ADA Building and Site Access Consultation

Facility Name: Main Street

Location: Main Street, Skagway AK 99840

Date of Assessment: 05/04/2023

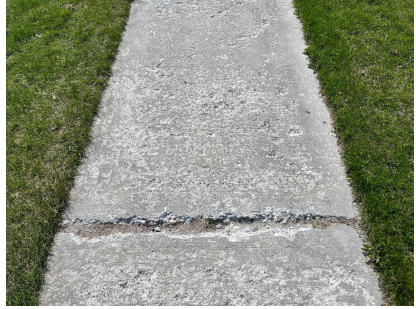
<p>35.151 Construction and alterations: streets, roads, sidewalks, highways</p>	<p>Transitions from the walkway to the street must be flush (level) and free of abrupt level changes</p>	<p>Curb removal or installation of an additional curb ramp at site of abrupt transition⁴</p>	<p>Main Street and Second Ave</p>	 <p><i>Curb in the right of access from the street to the sidewalk.</i></p>
<p>35.151 Construction and alterations: streets, roads, sidewalks, highways</p>	<p>Transitions from the walkway to the street must be flush (level) and free of abrupt level changes</p>	<p>Curb removal or installation of an additional curb ramp at site of abrupt transition⁵</p>	<p>Main Street and Third Avenue</p>	 <p><i>Curb in the right of access from the street to the sidewalk.</i></p>
<p>35.151 Construction and alterations: streets, roads, sidewalks, highways</p> <p>302.3 Openings in Ground</p>	<p>Gaps and/or damage in sidewalk access route exceed ½ inch wide and ¼ inch tall in places</p> <p>Transitions from the walkway to the street must</p>	<p>Repair concrete path</p> <p>Curb removal or installation of an additional curb ramp at site of abrupt transition</p>	<p>Main Street and Third Avenue</p>

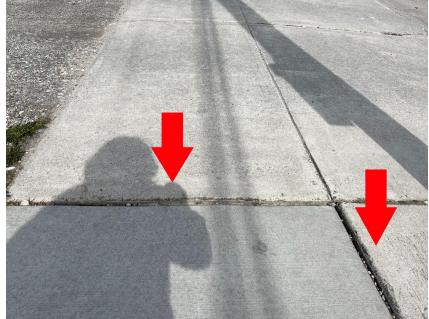
<p>35.151 Construction and alterations: streets, roads, sidewalks, highways</p> <p>302.3 Openings in Ground Surface</p> <p>303 Changes in Level</p>	<p>Gaps and/or damage in sidewalk access route exceed ½ inch wide and ¼ inch tall in places</p> <p>Transitions from the walkway to the street must be flush (level) and free of abrupt level changes</p> <p>Grass patch is elevated into the path of travel, creating a tripping hazard</p>	<p>Repair concrete path</p> <p>Curb removal or installation of an additional curb ramp at site of abrupt transition</p> <p>Re-pave the path in its entirety</p>	<p>Main Street and Eighth Avenue</p>	 <p><i>Large defect in public access route, curb in the right of access from the street to the sidewalk, and grass patch</i></p>
<p>35.151 Construction and alterations: streets, roads, sidewalks, highways</p> <p>302.3 Openings in Ground Surface</p>	<p>Gaps and/or damage in sidewalk access route exceed ½ inch wide and ¼ inch tall in places</p> <p>Transitions from the walkway to the street must be flush (level) and free of abrupt level changes</p>	<p>Repair concrete path</p> <p>Curb removal or installation of an additional curb ramp at site of abrupt transition</p>	<p>Main Street and Eighth Avenue</p>	 <p><i>Large defect in public access route and curb in the right of access from the street to the sidewalk.</i></p>

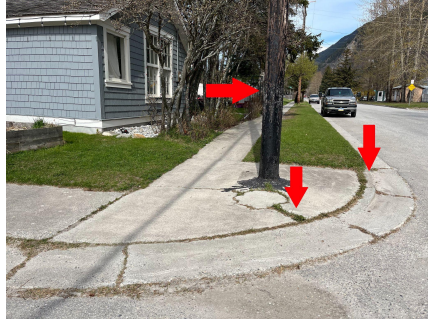
<p>302.3 Openings in Ground Surface</p>	<p>Gaps and/or damage in sidewalk access route exceed ½ inch wide and ¼ inch tall in places</p>	<p>Repair concrete path</p>	<p>Main Street between Eighth and Ninth Avenue - North Sidewalk</p>	 <p><i>Large defect in public access route</i></p>
<p>35.151 Construction and alterations: streets, roads, sidewalks, highways</p> <p>302.3 Openings in Ground Surface</p>	<p>Gaps and/or damage in sidewalk access route exceed ½ inch wide and ¼ inch tall in places</p> <p>Transitions from the walkway to the street must be flush (level) and free of abrupt level changes</p>	<p>Repair concrete path</p> <p>Curb removal or installation of an additional curb ramp at site of abrupt transition</p>	<p>Main Street and Ninth Avenue</p>	 <p><i>Large defect in public access route and curb in the right of access from the street to the sidewalk.</i></p>
<p>302.3 Openings in Ground Surface</p>	<p>Gaps and/or damage in sidewalk access route exceed ½ inch wide and ¼ inch tall in places</p>	<p>Repair concrete path</p>	<p>Main Street between Ninth and Tenth Avenue</p>	 <p><i>Large defect in public access route</i></p>

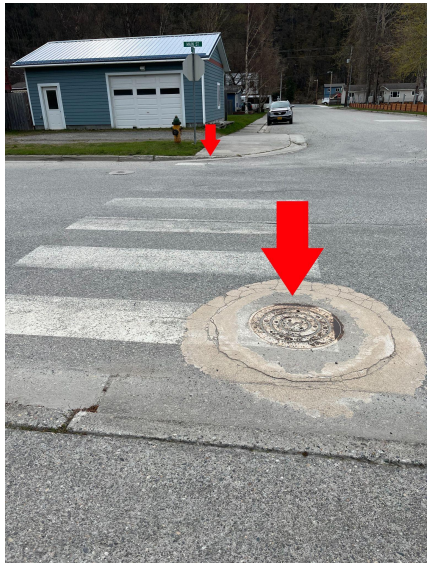
<p>302.3 Openings in Ground Surface</p>	<p>Gaps and/or damage in sidewalk access route exceed ½ inch wide and ¼ inch tall in places</p>	<p>Repair concrete path</p>	<p>Main Street between Fourteenth and Fifteenth Avenue</p>	 <p><i>Large defects in public access route</i></p>
<p>35.151 Construction and alterations: streets, roads, sidewalks, highways</p> <p>302.3 Openings in Ground Surface</p>	<p>Gaps and/or damage in sidewalk access route exceed ½ inch wide and ¼ inch tall in places</p> <p>Transitions from the walkway to the street must be flush (level) and free of abrupt level changes</p>	<p>Repair concrete path</p> <p>Curb removal or installation of an additional curb ramp at site of abrupt transition</p>	<p>Main Street and Fifteenth Avenue - North Sidewalk</p>	 <p><i>Large defect in public access route and curb in the right of access from the street to the sidewalk.</i></p>
<p>302.3 Openings in Ground Surface</p>	<p>Gaps and/or damage in sidewalk access route exceed ½ inch wide and ¼ inch tall in places</p>	<p>Repair concrete path</p>	<p>Main Street and Fifteenth Avenue - North Sidewalk</p>	 <p><i>Large defects in public access route</i></p>
